CITY OF ALBUQUERQUE

April 30, 2019

RE: Cooperative Educational Services (CES) 10601 Research Rd. SE Grading and Drainage Plan Engineer's Stamp Date: 04/15/19 Hydrology File: M21D021

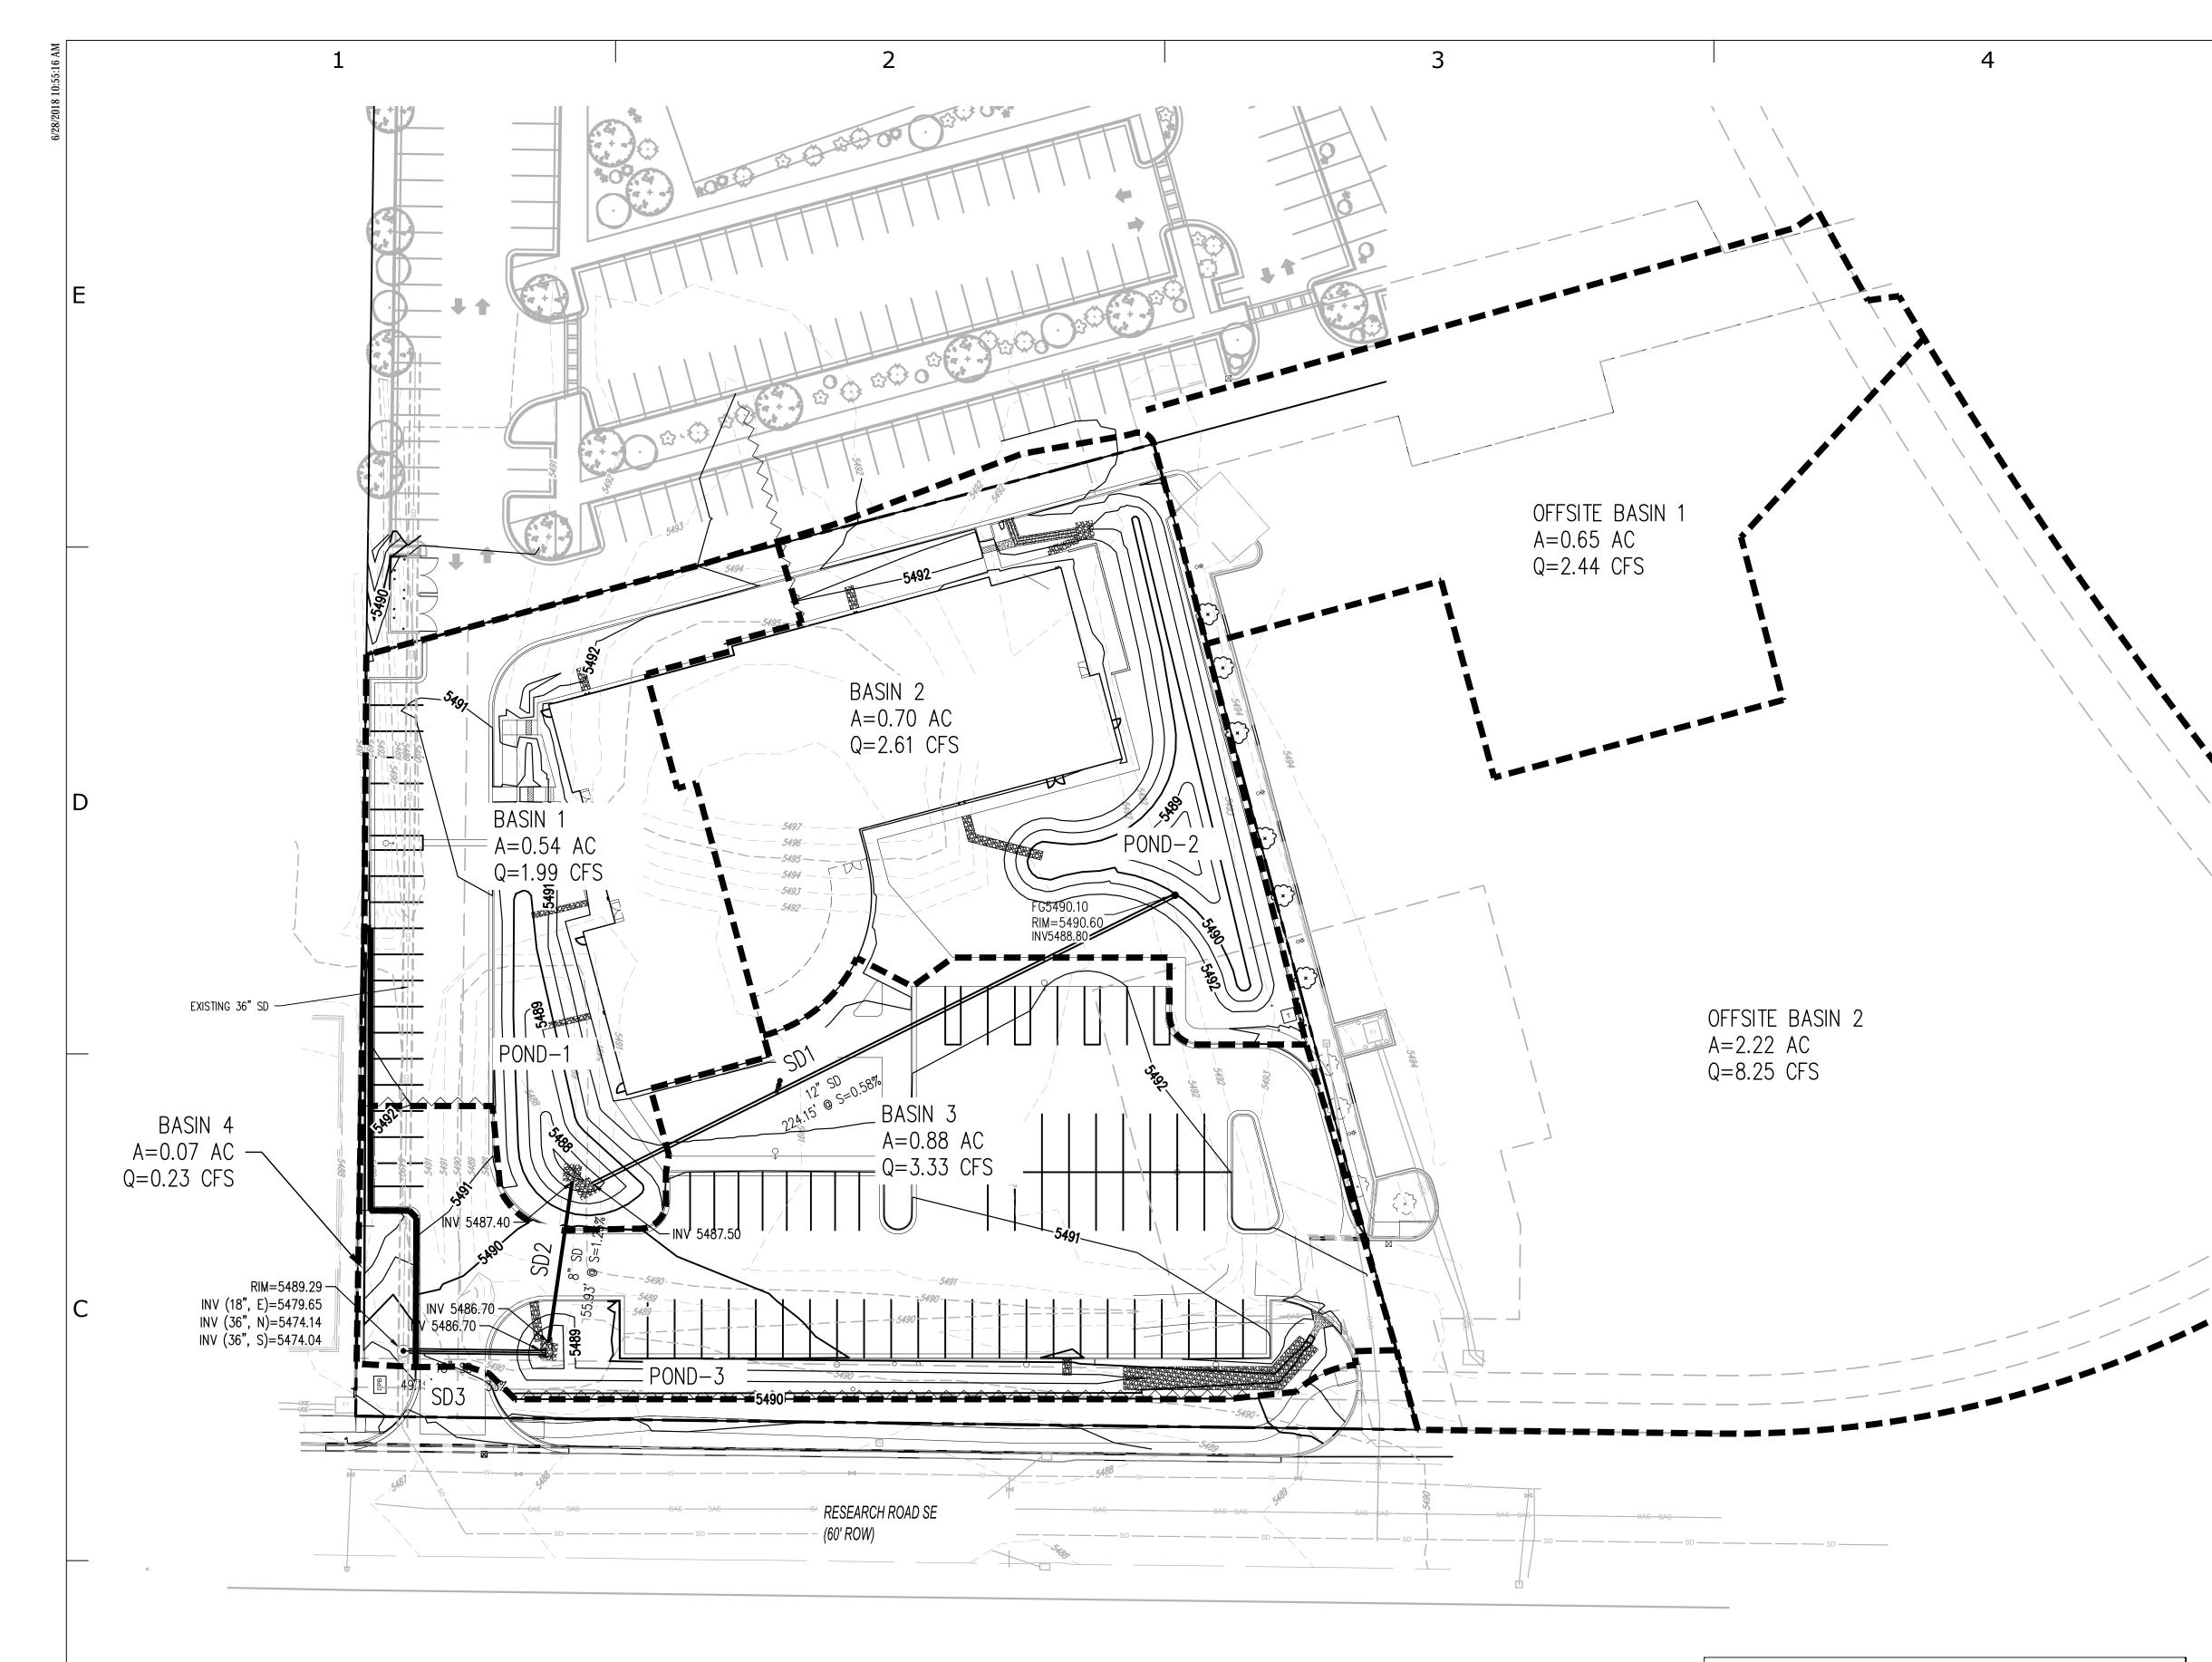
5. Sheet C300. Please label the existing 36-inch storm pipe.

- 6. Sheet C300. At the SW entrance, please label the existing storm manhole rim elevation. This manhole also appears to be within the proposed gutter. Please ensure that this is buildable and that Transportation does not have an issue with this. Also please label the proposed new elevation of the manhole rim. This will have to be adjusted (lowered).

- 7. Sheet C300. The proposed storm drain pipe within the existing 35' Public Drainage Easement must be RCP. If the proposed private storm drain pipe is to be HDPE, then at the edge of the drainage easement please call out the connector from HDPE to RCP and provide a detail. The whole storm drain pipe at this location could also be RCP.

- 11. Sheet C300 & C302. Please label the site plan items on the adjacent property to the North as future development.
 - 12. Sheet C300. In Section A-A, please add the 35' Public Drainage Easement.

- 13. Sheet C302. Please add the drainage arrows for site.
 - 14. Sheet C302. Please show the Stormwater Quality volume provided within each pond along with the water surface elevation of the SWQ volume in a chart.

- 15. Sheet C302. Please use the broad crest weir equation in the DPM for the curb cuts. If you use a "C" value of 2.7, then the proposed 4 ft curb cuts can be reduced to a 2 ft curb cut and the 9 ft curb cut will be reduced to a 5 ft curb cut.
